ROAD SAFETY AUDIT REPORT

OREGON DEPARTMENT
OF TRANSPORTATION
OR 8: SW 17th Avenue
to S 26th Avenue

ROAD SAFETY AUDIT (RSA) REPORT

OR 8: SW 17th Avenue to S 26th Avenue Washington County, Oregon

Exhibit 16: Location of Minor Streets and Accesses

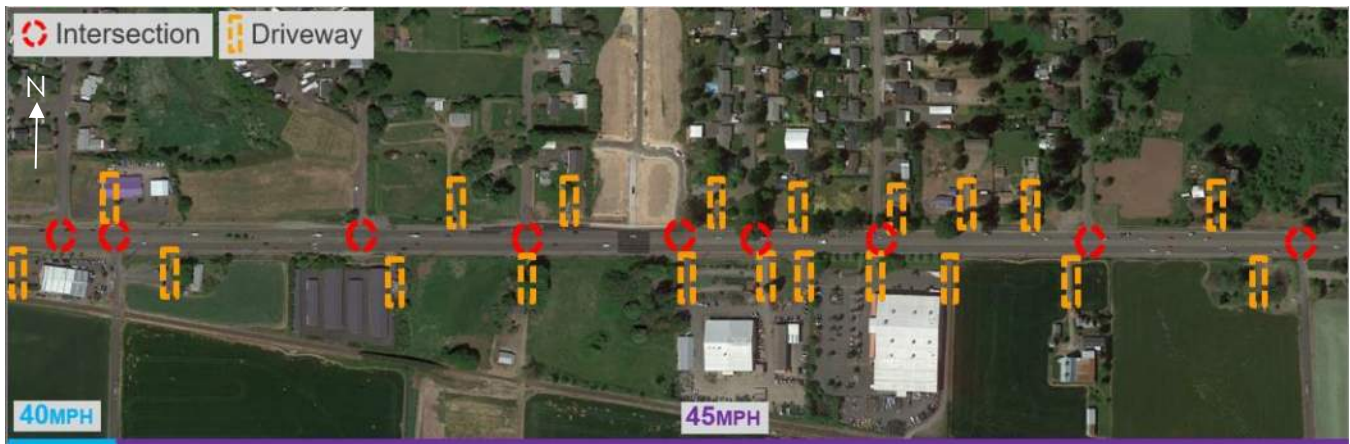
The RSA team determined the density of combined minor streets and accesses was also an issue. From N 31st Avenue to SW 331st Avenue, there are numerous intersections and driveways (see Exhibit 16).

Although a direct correlation between access density and the crashes on the corridor cannot be made, there is potential for the crashes to be associated with vehicle movements near minor intersections and/or driveways. The following observations can be made regarding the reported crash data.

Exhibit 19: Reported 2013-2017 Collision Types by Milepost

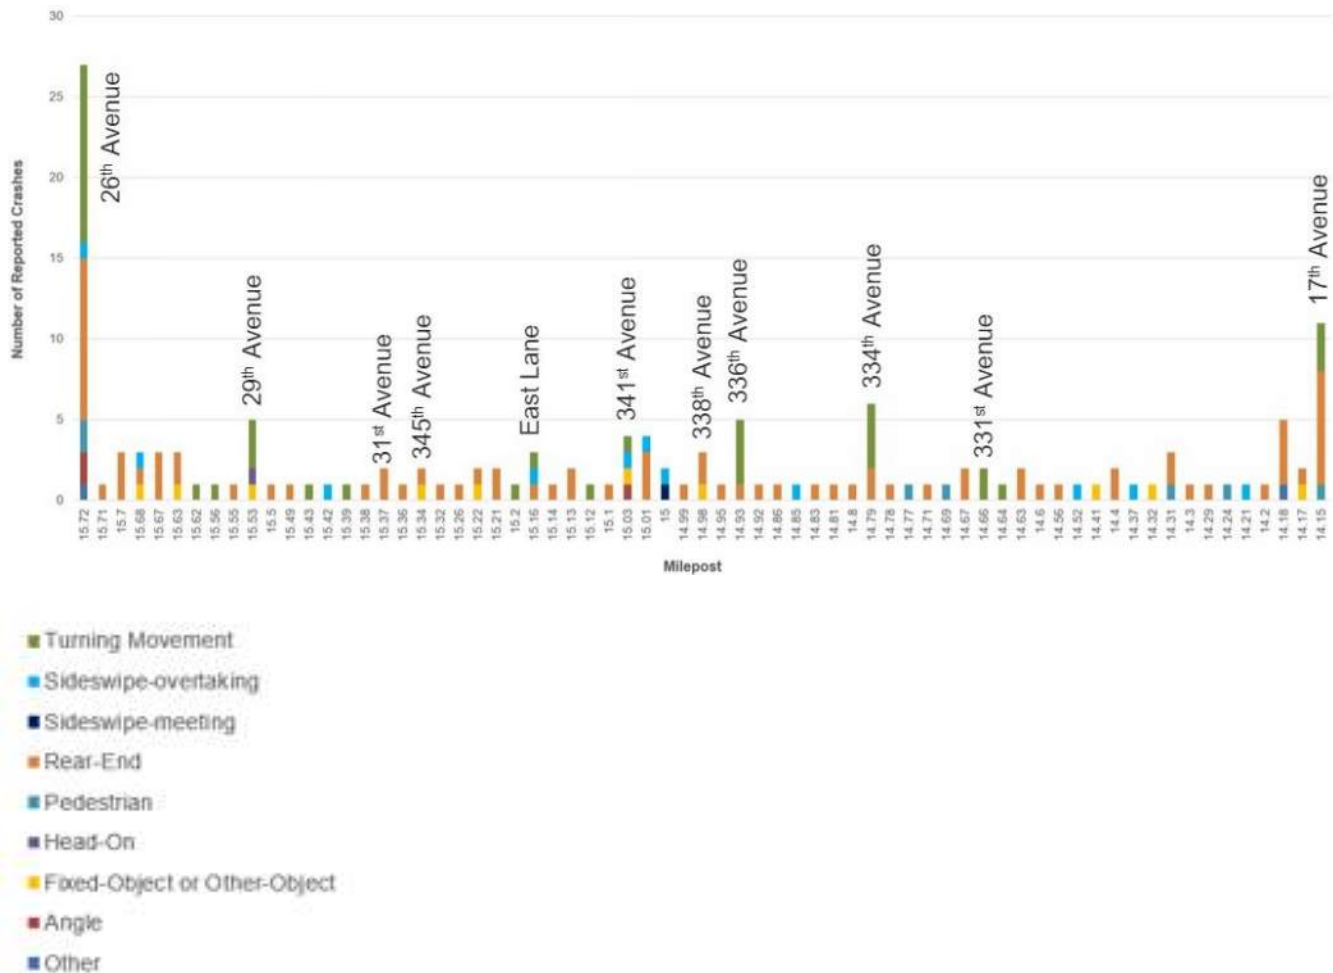
The crash data show that there were a high number of rear-end crashes which could be exacerbated by late and assertive deceleration at intersections due to limited intersection visibility. The data also show that the crashes are spread throughout the study corridor (as shown in orange in Exhibit 19).

At 336th Avenue looking east

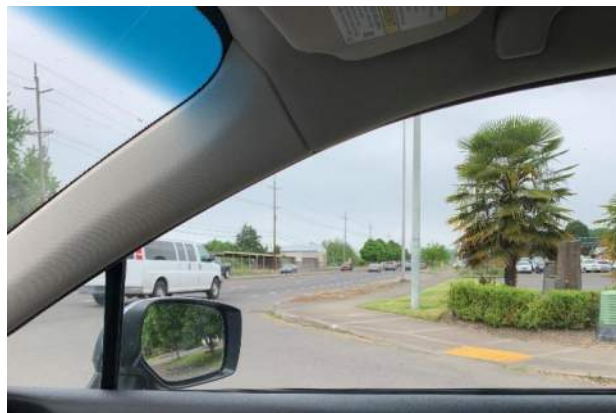
The intersection sight distance (ISD) is also an issue at some of the intersections along the corridor. Vehicles were observed pulling forward past stop bar and/or stop signs to see oncoming traffic. Examples of limited ISD are shown in the photos below:

Increasing intersection sight distance at unsignalized locations throughout the corridor will allow drivers to see oncoming traffic with enough advance warning to make turning movement decisions with adequate gaps. Substantial improvements may be completed by working with maintenance staff from agencies to maintain vegetation in the clear zones and remove trees, grass, and other vegetation that is encroaching on intersection sight distance triangles. Completing the bike skip striping along OR 8 through the intersection will help inform side-street drivers how far they may pull forward to achieve better sight distance without entering the travel lanes on OR 8.

Exhibit 20: Reported 2013-2017 Crash Severity by Collision Type at OR 8/26th Avenue

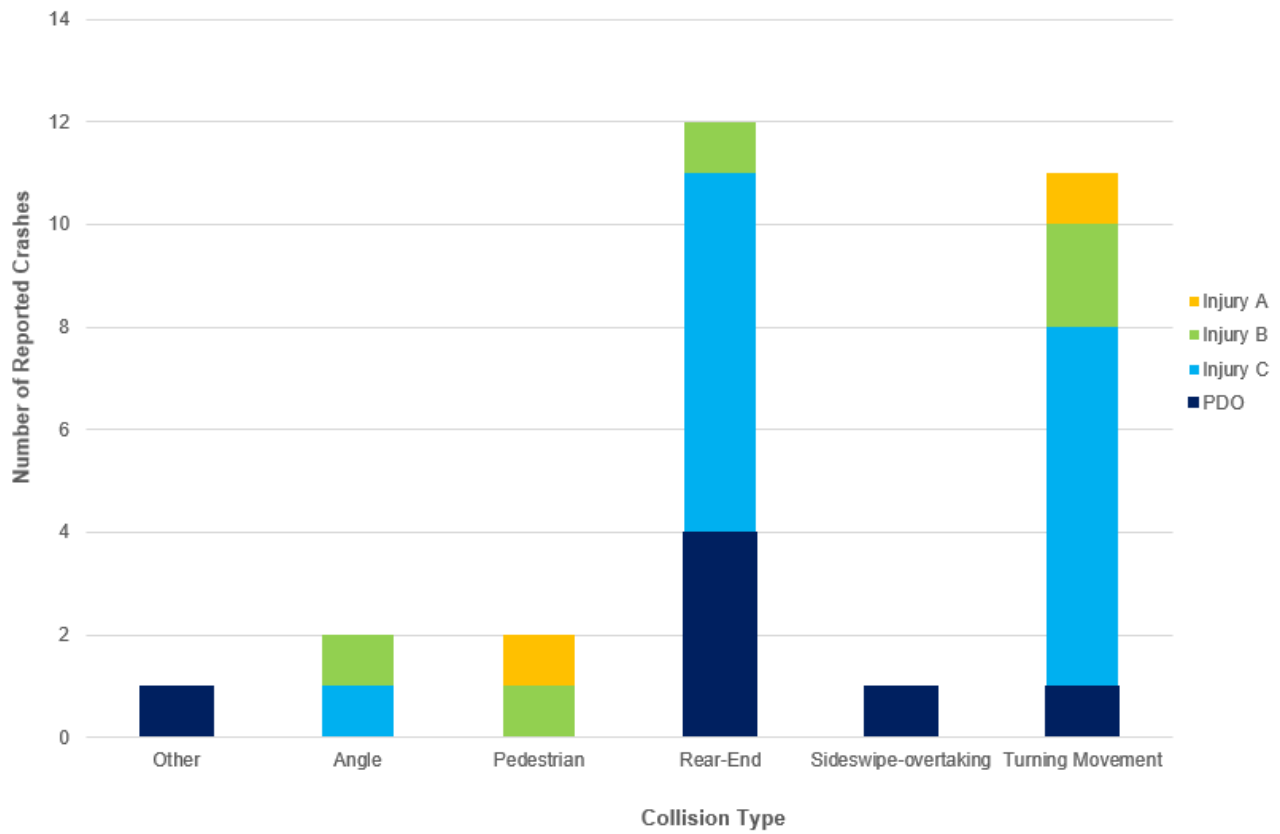
26th Avenue is a primary north-south route in Cornelius. This intersection had the highest total entering volume (TEV) of vehicles in the study corridor. Additionally, it had the most crashes of the study intersections. Most of the crashes at this intersection were either rear-end or turning movement (See Exhibit 20). In addition, OR 8/26th Avenue is identified on the 5% Safety Priority Index System (SPIS) list for 2017. Some key observations at the 26th Avenue intersection are summarized below:

- Highest transit ridership within the study corridor
- Curb ramps and crosswalk are not well aligned, especially due to the large curb radii in the northern intersection corners.
- East-west permitted-protected left turns
- Side streets have shared left/through and right lane configurations operating as permissive phasing that results in undesirable north-south left-turn driver confusion
- Medians with tubular markers are not visible
- Drivers of left-turning vehicles from OR 8 have trouble seeing opposing through traffic

Exhibit 21: Illustration of reallocation of cross-section width to accommodate buffered bicycle lane

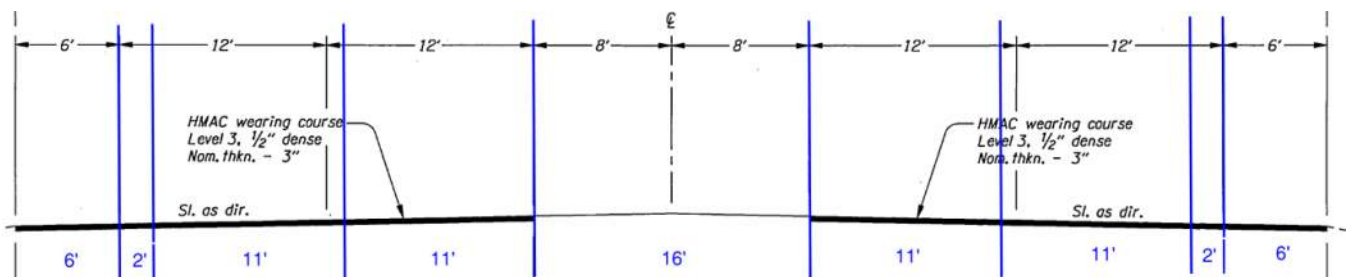
The existing cross-section of OR 8 includes bike lanes approximately six feet wide. However, there is currently no buffer separating bicyclists from vehicles. Due to the relatively high speeds and volume on OR 8, the cross-section may be reallocated to provide a buffer for further separation between vehicles and bicyclists. This may be achieved by reducing one or two lanes per direction to 11 feet in width and is consistent with ODOT's *Blueprint for Urban Design* principles. As shown in Exhibit 21, the lane skip stripe is the only stripe that would need to move (e.g., one foot) to accommodate the reallocation of space.

Exhibit 23: Illustration of potential near-term enhanced pedestrian crossing locations

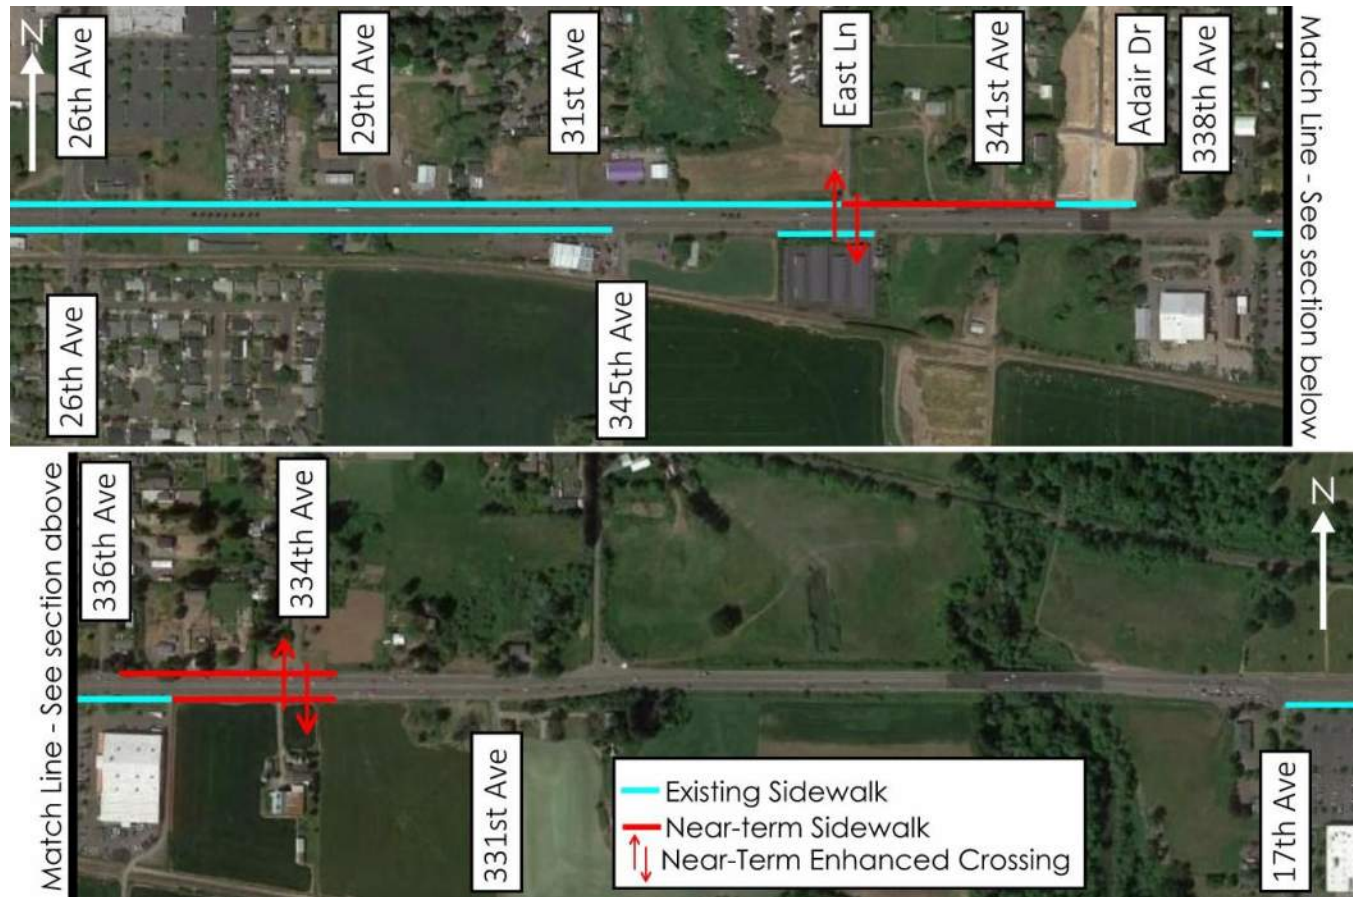
- East Lane:** This location has bus pull-outs. It also experiences relatively high transit ridership compared to other stops along the corridor. In addition, this location is approximately 0.1 miles west of the pedestrian crash at NW 341st Avenue. If the crossing is located on the east leg of the intersection, a pedestrian refuge island may be feasible and should be considered in a future engineering study.

The two crossings should be connected by sidewalk infill, as shown in red in Exhibit 23. Existing sidewalk is shown in blue in the exhibit. The sidewalk infill and enhanced crossings may provide an opportunity to consolidate bus stops within this section of the corridor.

Exhibit 25: Illustration of Mid-Term Vision for Connected Sidewalks and Enhanced Pedestrian Crossings

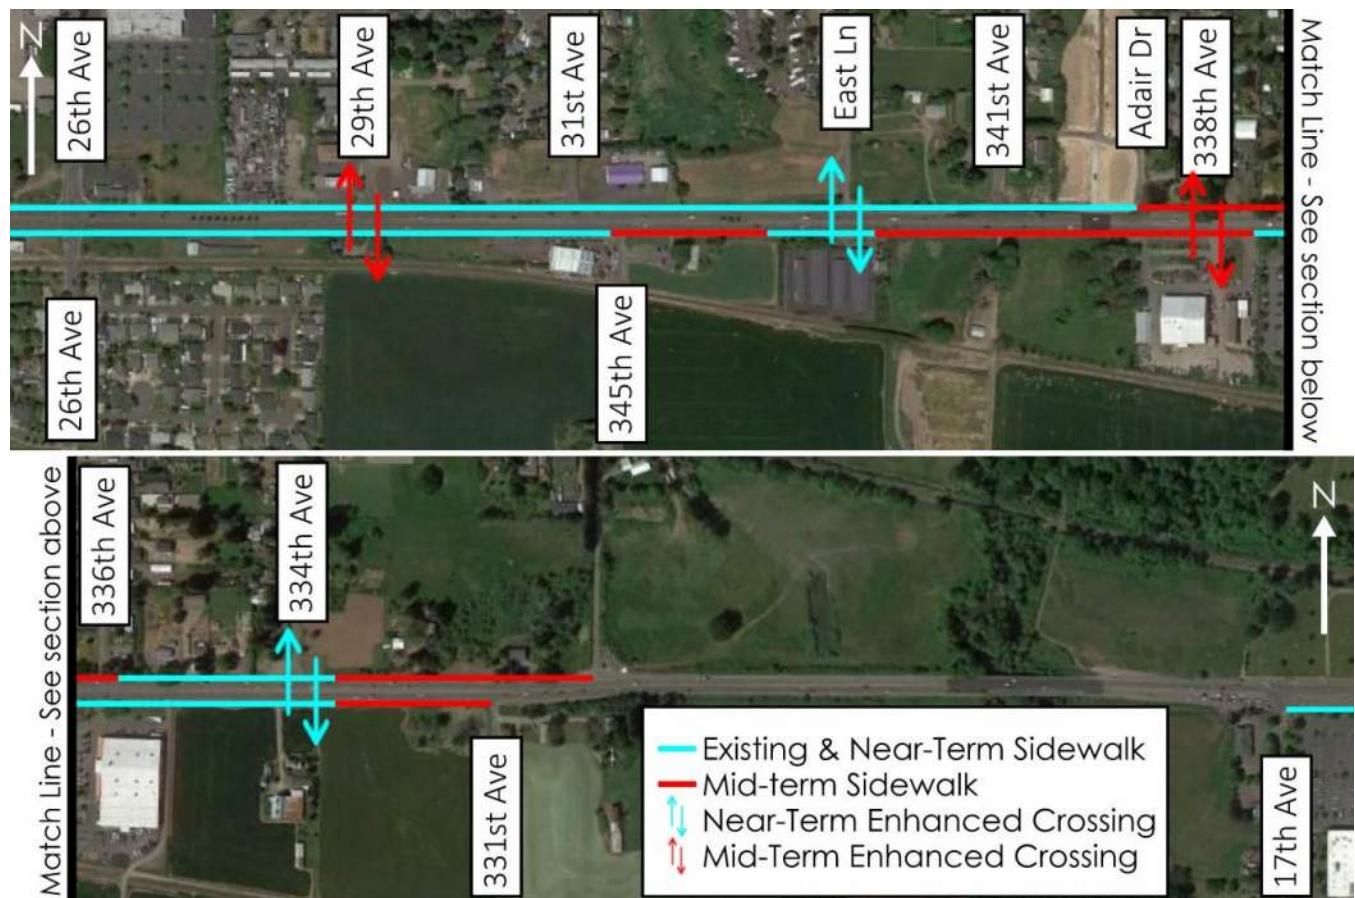
After the near-term suggested enhanced crossings are completed at East Lane and 334th Avenue, additional crossing locations should be identified and evaluated. These locations should be coordinated with bus stops and sidewalk connections to provide a complete, connected pedestrian system for the study corridor. OR 8 should be evaluated using guidance from ODOT's *Blueprint for Urban Design* to determine appropriate target spacing between crossings, identify potential locations, and identify appropriate treatments.

As shown in Exhibit 25, potential additional mid-term crossings (shown in red) could be located at 29th Avenue and 338th Avenue, with connecting sidewalk (also shown in red). The near-term suggested crossings and sidewalk infill are shown in blue in the exhibit. Bus stops adjacent to these crossing locations should be evaluated and upgraded. Consolidating bus stops to these crossing locations may also be considered.

Exhibit 26: Potential Long-term Pedestrian Connection: Shared-use Path from 331st Avenue to 17th Avenue

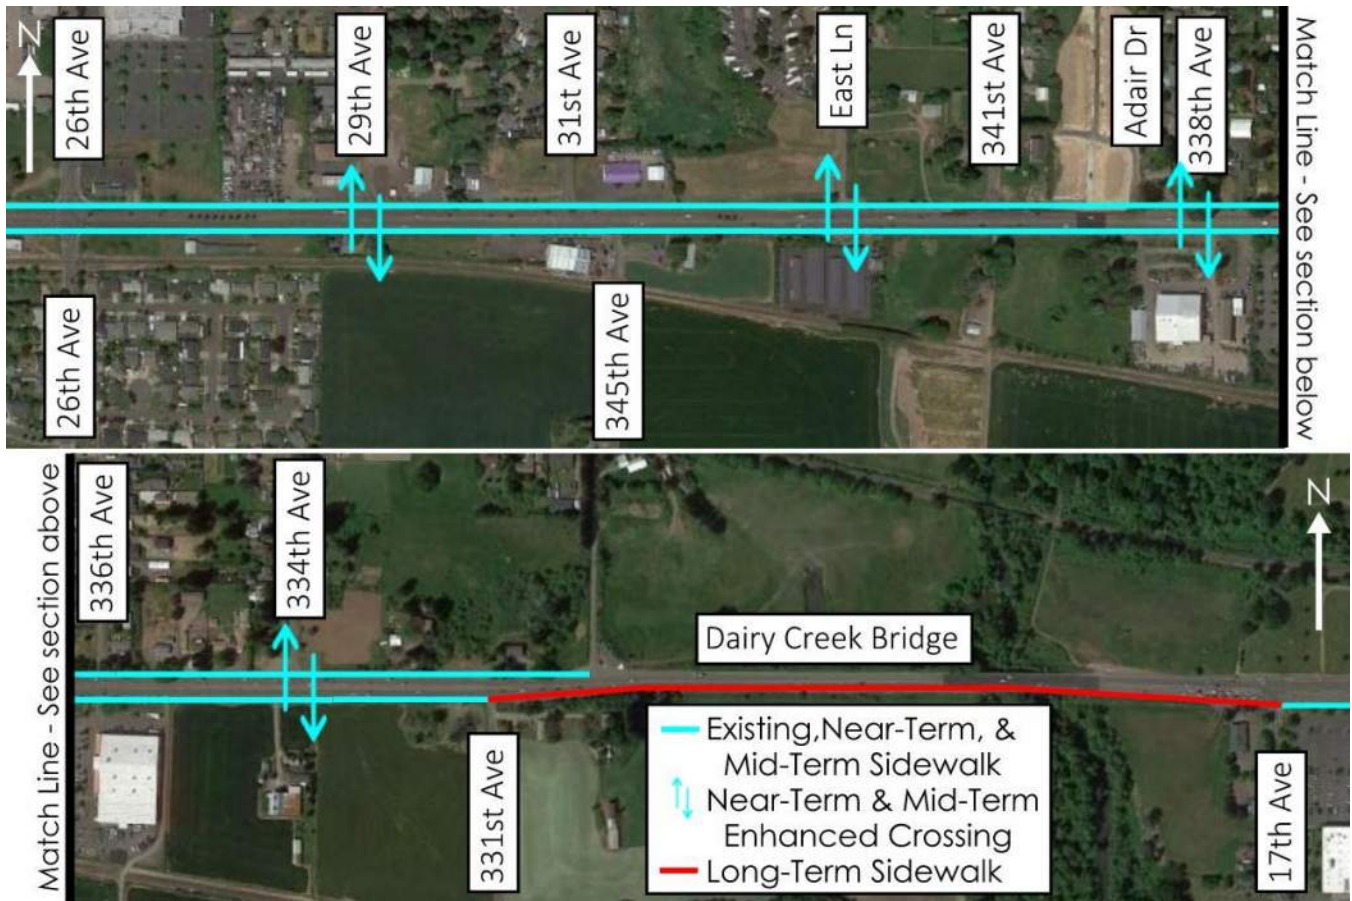
It should be noted that Cornelius, Hillsboro, Forest Grove, and other agencies are continually reviewing the pedestrian and bicycle needs of this area. One potential project is the Council Creek trail along the ODOT rail tracks that run parallel of OR 8 to the north. Additionally,

Hillsboro is currently updating their TSP and expect to identify projects for the pedestrian and bicycle networks on the study corridor.

Exhibit 29: Illustration of Signalized Option

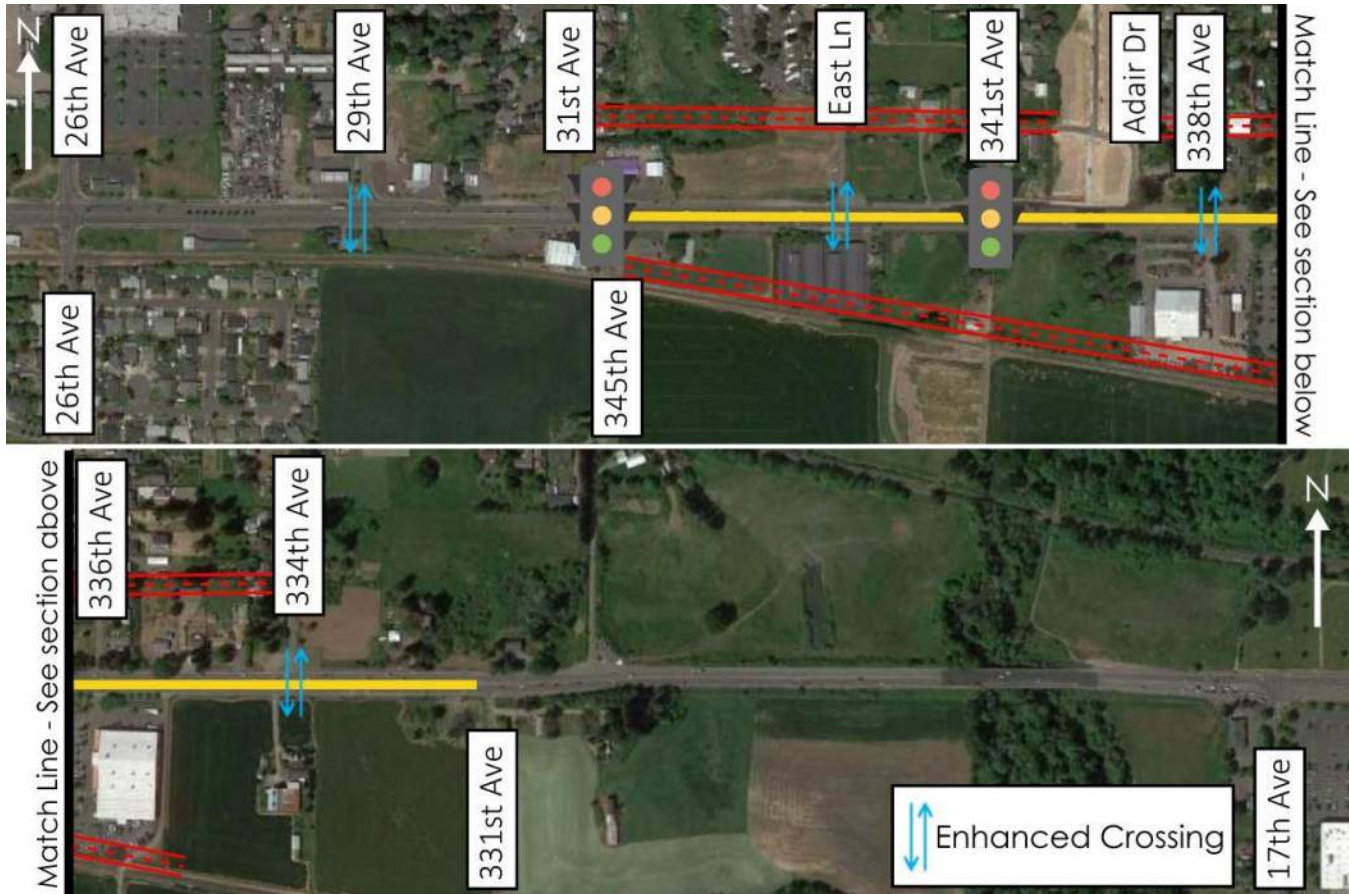
Signals may be considered at 345th Avenue and 341st Avenue, as shown in Exhibit 29. As part of improvements at 345th Avenue (south leg), 31st Avenue (north leg) may be realigned with 345th Avenue. With this realignment and a nearby planned school, the intersection may meet signal warrants. The City of Cornelius' TSP identifies the 341st Avenue intersection for a potential signal, but only if the frontage roads are implemented and the intersection meets signal warrants.

CRF: In urban areas, traffic signals are associated with a 67% reduction in angle crashes but also a 143% increase in rear-end crashes. (ODOT Countermeasure Number: H20).

In rural areas, traffic signals are associated with a 77% reduction in angle crashes but also a 58% increase in rear-end crashes. (ODOT Countermeasure Number: H20 and H21)
